Illinois Tollway Base Sheet Revisions

Section M	Base Sheet Drawings	
	Drawing	Modification Summary Effective: 03-01-2024
	Pole Assembly (ITS)-Series 1000	
	M-ITS-1000	Elevation Views Pole Mounted ITS Element Assembly

SPACER - DUCT PACKAGE IN A TRENCH

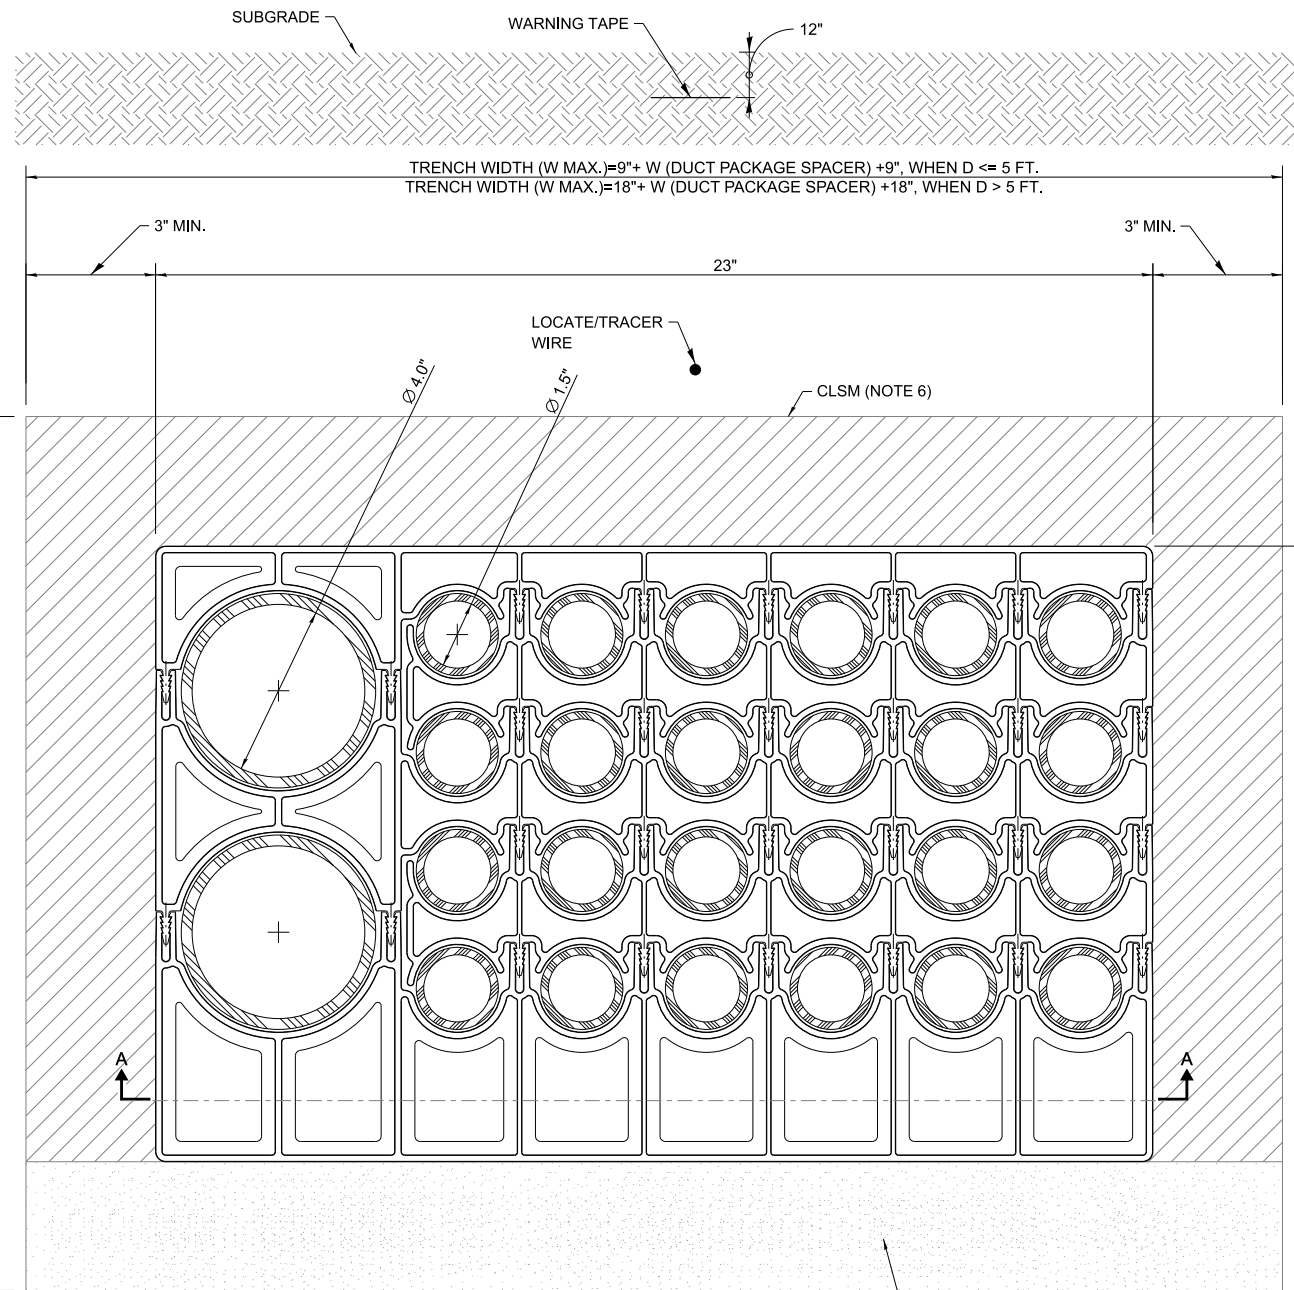
Sheet 2	Section B-B (Type A) and Section B-B (Type B): service pad 1" above grade
		Align Section B-B with Plan view on top
		In plan view for concrete service pad type C: moved arrow for Section B-B upward
		Concrete service pad Type C: service pad 1" above grade
	M-ITS-1004	Spacer - Duct Package in a Trench
		New details of duct spacer for duct bank in a trench showing the conduit arrangement for fiber and power
